**STAFF REPORT
HISTORIC AND CULTURAL LANDMARKS COMMISSION
CITY OF FORT WORTH, TEXAS**

DATE: December 12, 2016

REQUEST	Certificate of Appropriateness
APPLICANT/AGENT	Kenneth Haliburton
LOCATION	2317 Carverly Drive
ZONING/ USE (S)	B/HC
NEIGHBORHOOD ASSOCIATION	Historic Carver Heights

Applicant requests a Certificate of Appropriateness to rehabilitate the exterior and alter the roof of the main house.

Front Elevation – Existing

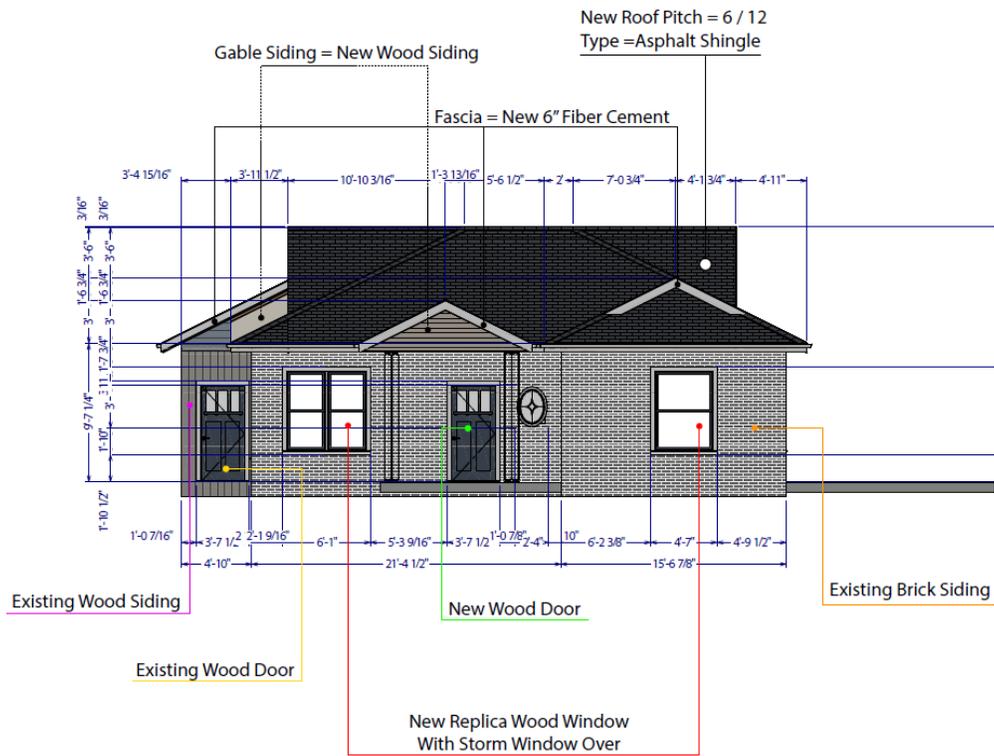
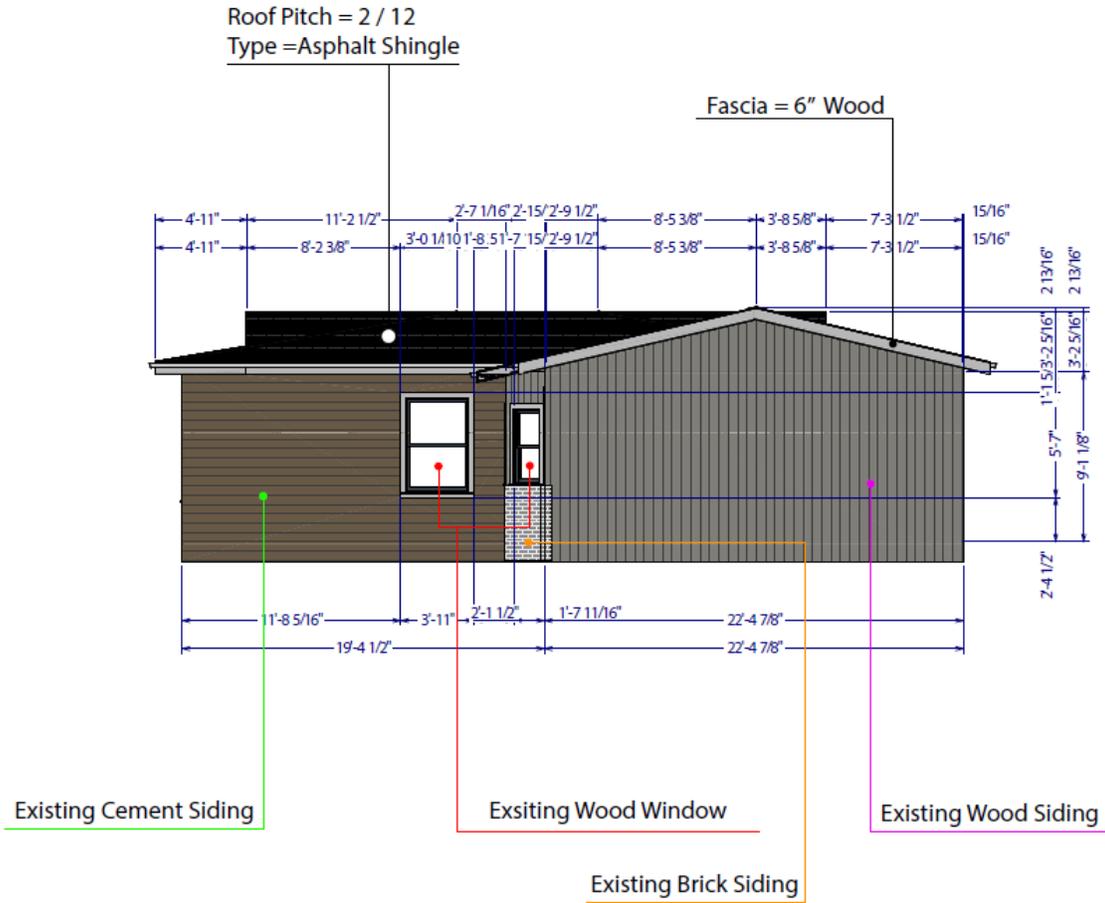
In addition to the proposed rehabilitation, the applicant seeks to alter the roof pitch from 2:12 to 6:12 in order to accommodate air conditioning ductwork and service access. This aspect of the proposed work is significant and is considered “not appropriate” in the Historic Carver Heights Design Guidelines. The predominant historic character of roofs in the immediate environs is low-pitched and a scan of nearby properties show evidence of a remarkably consistent roof form and pitch.

A key preservation principle is to “do as much as necessary and as little as possible”. Staff have suggested that a mechanical plan showing the horizontal and vertical layout of the air conditioning system be provided to inform the extent to which the roof needed to be altered. In addition, the consideration of alternative measures that may not require such an intervention to the roof form has been suggested.

That the Application for a Certificate of Appropriateness to undertake exterior rehabilitation and alter the roof pitch be approved subject to the following conditions:

- 1. That the applicant explore alternatives to providing air conditioning without having to raise the entire roof pitch in a way that is inconsistent with the Historic Carver Heights Design Guidelines; and**
- 2. That revised drawings satisfying the above condition be submitted to the Planning and Development Department prior to the issuance of a Certificate of Appropriateness**
